SOLICITATION AMENDMENT MODIFICATION DE L'INVITATION

Title - Sujet Culvert Replacement	
Solicitation No. - N° de l'invitation EP899-180551/A	Amendment No. - N° modif. 001
Client Reference No. - N° de référence du client EP899-18-0551	Date 2017-08-11
GETS Reference No. - N° de référence de SEAG PW-\$PWA-122-5622	
File No. - N° de dossier PWA-7-78043 (122)	CCC No./N° CCC - FMS No./N° VME
Solicitation Closes - L'invitation prend fin at - à 02:00 PM on - le 2017-08-15	Time Zone Fuseau horaire Atlantic Daylight Saving Time ADT
F.O.B. - F.A.B. Plant-Usine: <input type="checkbox"/> Destination: <input checked="" type="checkbox"/> Other-Autre: <input type="checkbox"/>	
Address Enquiries to: - Adresser toutes questions à: Chinye (PWA), Chukwudi	Buyer Id - Id de l'acheteur pwa122
Telephone No. - N° de téléphone (902) 496-5476 ()	FAX No. - N° de FAX (902) 496-5016
Destination - of Goods, Services, and Construction: Destination - des biens, services et construction:

Amendment 001 is raised to incorporate the following.

Profile A from Drawing CO1 – Not to Scale

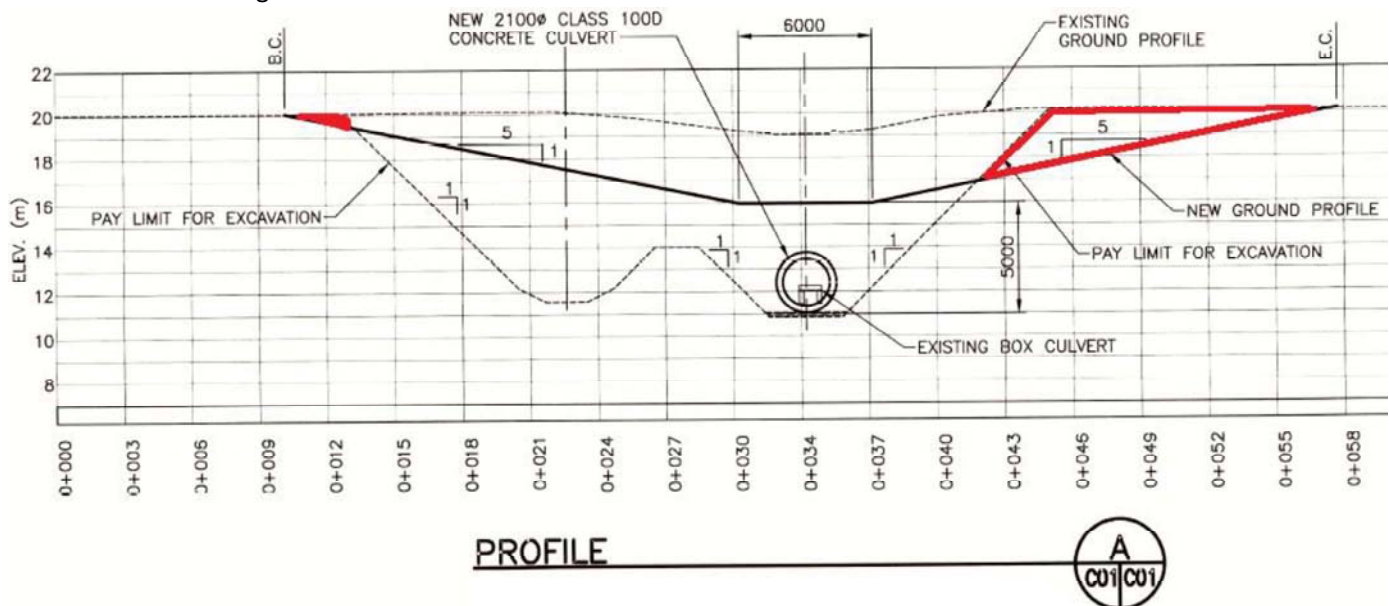
1. Volume of material on Profile A of Drawing CO1 below the "Pay Limit for Excavation" line but above the "New Ground Profile" line (volumes outlined in red below) is to be included in the price per unit rate for Excavation and Disposal (m^3) in Appendix 1-Combined Price form of the Invitation to tender document. The "Pay Limit for Excavation" line should follow the "New Ground Profile" line where they intersect. The Contractor will not be paid for any excavation and backfill beyond the "Pay Limit for Excavation" line.
